Rosemount Nuclear Instruments, Inc.  
8200 Market Boulevard  
Chanhassen, MN 55317 USA

Subject: Reply to NRC Notice of Nonconformance 99900271/2019-201-01

**Attachment**  
**Reply to NRC Notice of Nonconformance**  
**Docket No. 99900271 / Inspection Report No. 2019-201**

**Figure 3. Typical Test Set-up for Radiation Exposure**

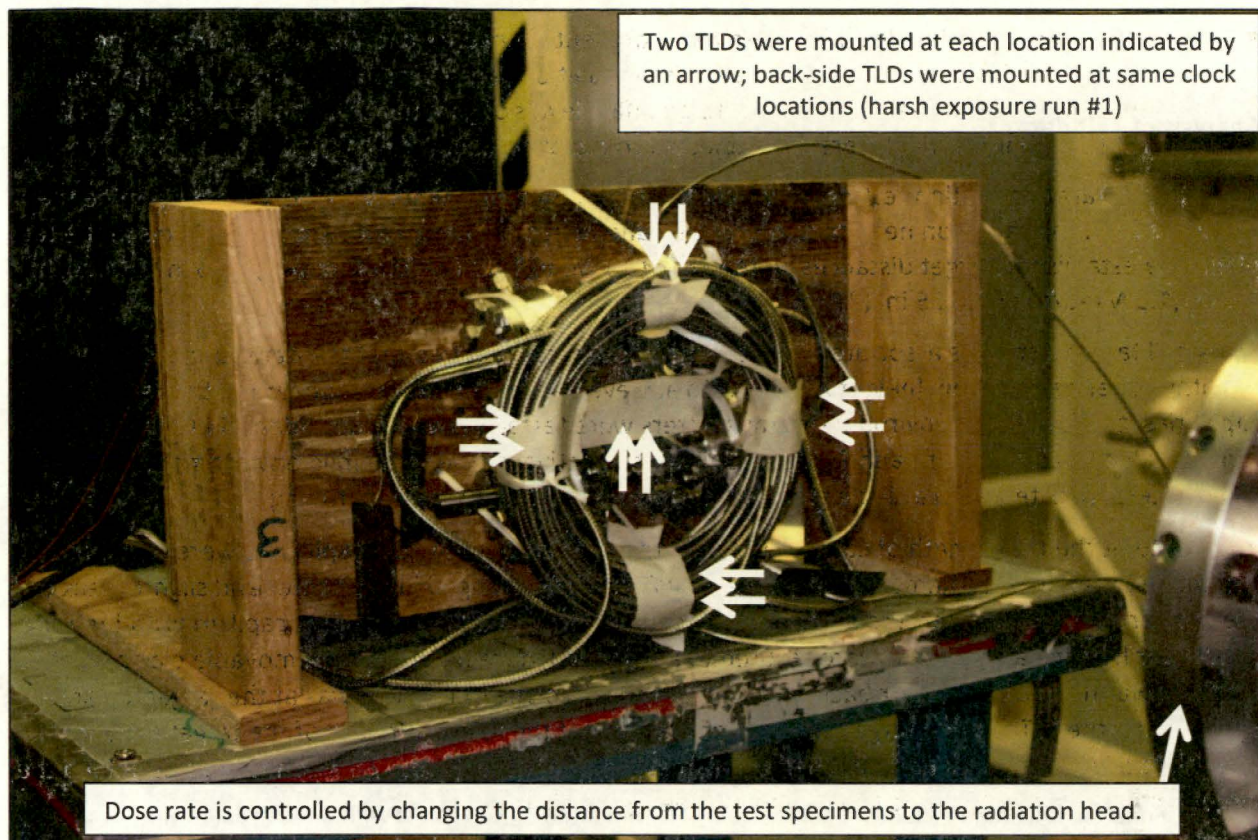
*The NRC inspection team identified that the testing protocol that was implemented associated with the radiation testing portion of RNII's 3159 nuclear qualified remote diaphragm seal and 3150 series pressure transmitters did not verify the adequacy of the design. Specifically, due to the way the 3159 nuclear qualified remote diaphragm seal and detector assemblies were mounted in the*

*radiation chamber and the way that the associated radiation dose was measured, the test samples may have received significantly less radiation dose than what was called for in the test plan and captured in the analysis. In addition, the NRC inspection team identified that the remote seal assemblies were installed in the test chamber in such a way that the capillary tubing was looped into multiple circles such that the loops on the outside would shield some of the other loops from the radiation field emitted from the test source. Also, the thermoluminescence dosimeters (TLDs) used to measure the field were placed primarily on the outer loops closest to the test source, so the actual measured radiation would not have been indicative of the dose received by the loops farthest away from the source. The only non-metallic component of the seal assembly is the fluid encased in the capillary tubing, so it is this fluid that is the primary concern with respect to ensuring an accurate assessment of the applied radiation dose. Preliminary calculations performed by RNII during the inspection, showed that the shielding effects could be significant and could have resulted in a large percentage of the coil loops receiving less than the dose designated in the test plan. The overall impact of this on the stated accuracy numbers was indeterminate at the end of the inspection as margin may exist in other portions of the analysis. RNII entered this issue into their corrective action program under CAPA No. 004435.*

In order to fit the total length of capillaries within the defined window, the capillaries were coiled and tied into a loose bundle. Remote seals/lower housings were arranged in the center and slightly back of the capillary coils to allow access to the process connections. The IUTs (including capillaries and remote seal/lower housing assemblies) were secured to a wooden fixture mounted on a movable platform. The platform was moved forward or backward so that the mid-plane of the IUTs was at the target distance. By centering the IUTs on the target line, half of the mass of the IUTs is forward of the target distance and will receive more radiation; and half of the mass (mostly remote seals/lower housings) is behind the target distance and will receive less radiation. See Figures 3 and 4.

At target distances greater than 12 inches, the radiation fields generated by each of the four 15 kCurie gamma sources (Cobalt 60) overlap and provide a relatively uniform distribution of radiation across the test area. At target distances less than 12 inches, the radiation fields generated by the four gamma sources don't overlap and the items under test will see four separate gamma sources. Therefore, at the smaller target distances, there will be localized areas with higher and lower dose rates and the distribution of gamma radiation will be non-uniform over the test area. There will also be a decrease in dose rate with distance from the sources— independent of potential self-shielding effects.

Thermoluminescent dosimeters (TLDs) were mounted on the front-side of the capillaries and the front-side of the remote seals to validate the pre-test dosimetry and to obtain data relative to the expected variation across the test area. These TLD dose rate measurements were utilized in the qualification program, along with test time, to calculate TID levels achieved. TLDs were also mounted on the back-side of the capillaries in the mild environment test group and harsh environment run #1 as shown in Figure 4 (note that the capillary back-side TLD data was retrieved from the original test lab documentation following the NRC inspection and therefore RNII was not able to present that information to the NRC at the time of the inspection). Although the capillary bundle back-side TLD data was taken during the first two runs, it was not incorporated into the original 3159 qualification TID calculations because it was not available for all runs. As identified by the inspection team, only using the front side TLD's might have resulted in a non-conservative TID calculation with respect to target values as the effects of capillary self-shielding were not expressly accounted for. As a result, RNII has conducted a more detailed analysis which is discussed further in the next section.
